ADDENDUM No. 01

DATE: March 16, 2022

PROJECT: C22-01 SAVANNAH ARTS ACADEMY ADDITION & RENOVATION  
SAVANNAH-CHATHAM COUNTY PUBLIC SCHOOL SYSTEM, SAVANNAH, GA

BY: COGDELL & MENDRALA ARCHITECTS, PC (Architect)  
517 East Congress Street  
Savannah, GA 31401

**PROJECT NO:** 1916  
**DATE:** FEB 2022  
**DRAWN BY:** EJM  
**SCALE:** As indicated  
**SHEET:** **A8.01**

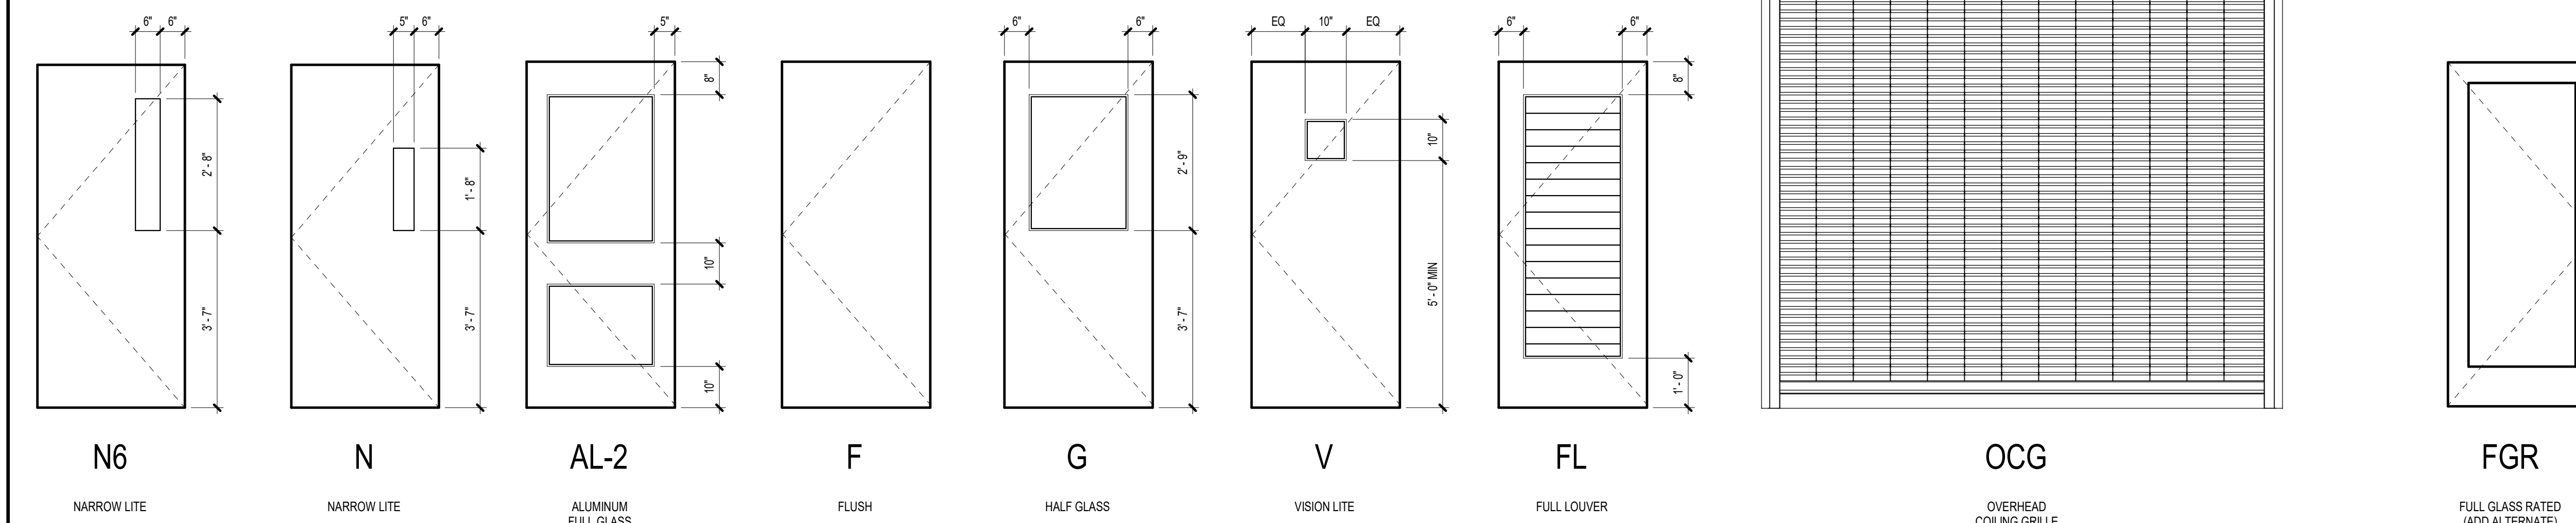
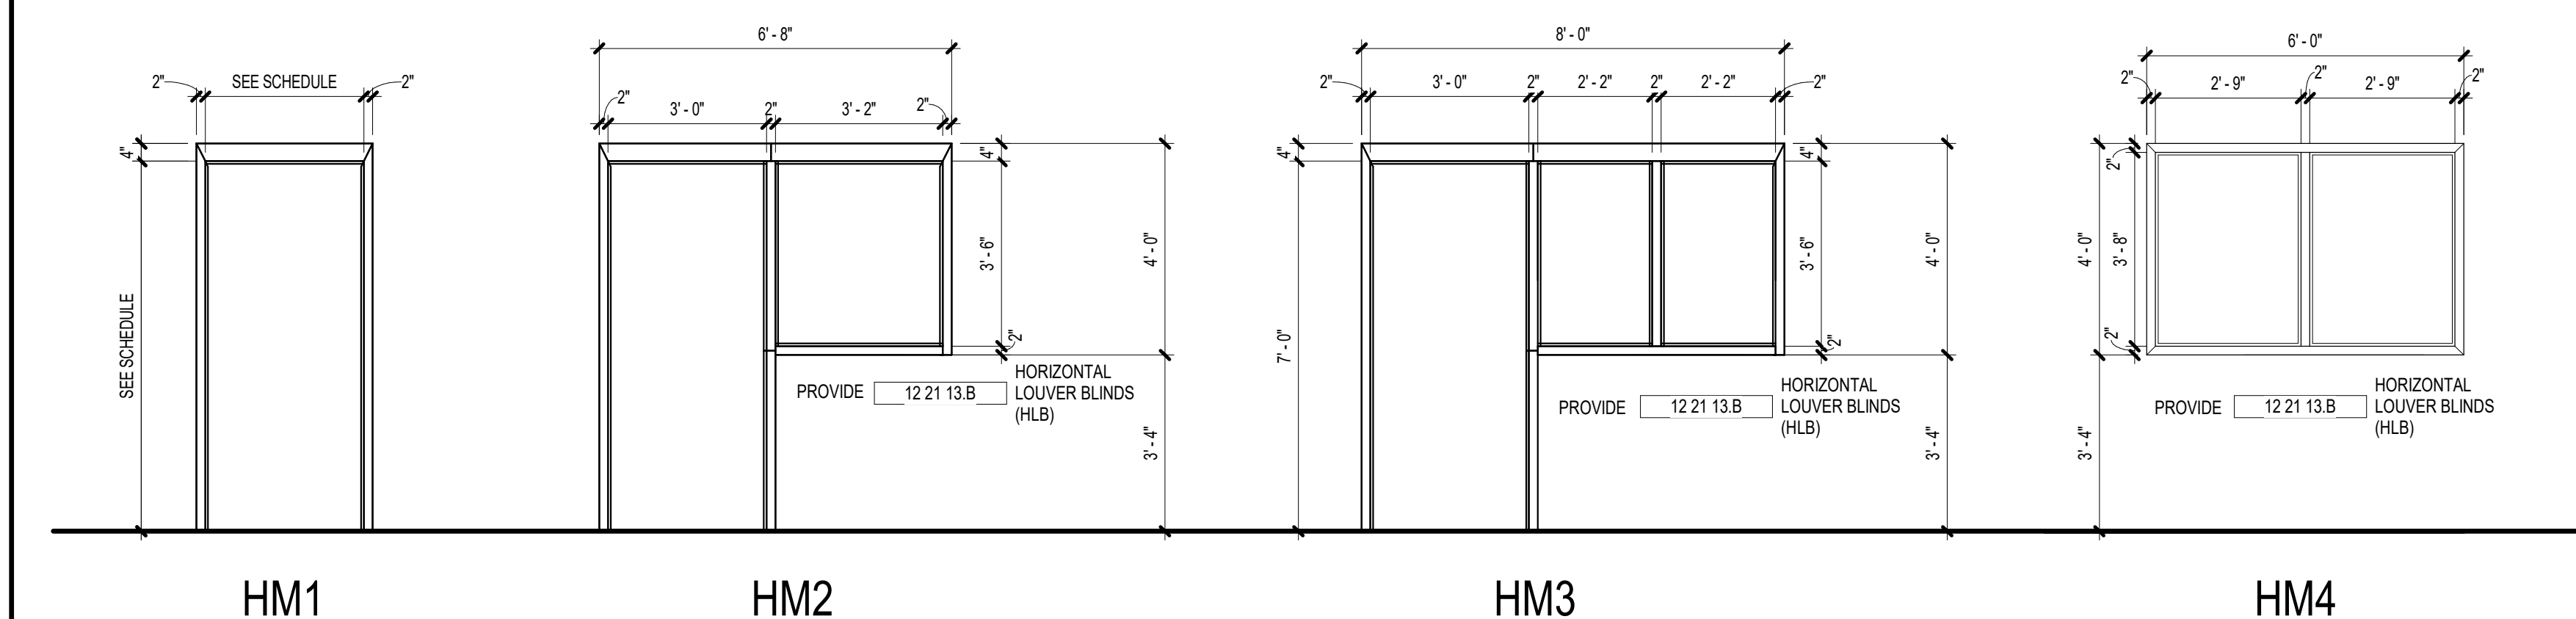
1. Response: 31 31 16 Termite Control specification has been added with regard to any new work.
- C. The description of Alternate #6 for Savannah Arts Academy Addition states that the doors at Opening #500A in the Base Bid are Wood. The Door Schedule shows them as Hollow Metal. Which material is correct for the Base Bid?

1. Response: Opening is intended to be Wood. Please see revised Vol II – A8.01 for clarification.
- D. Openings 102.E and 127.2 are not scheduled with a Hardware Set and they do not occur in specified hardware sets in Division 087100. Do these openings require new hardware or is all hardware at these two openings existing to be reused?
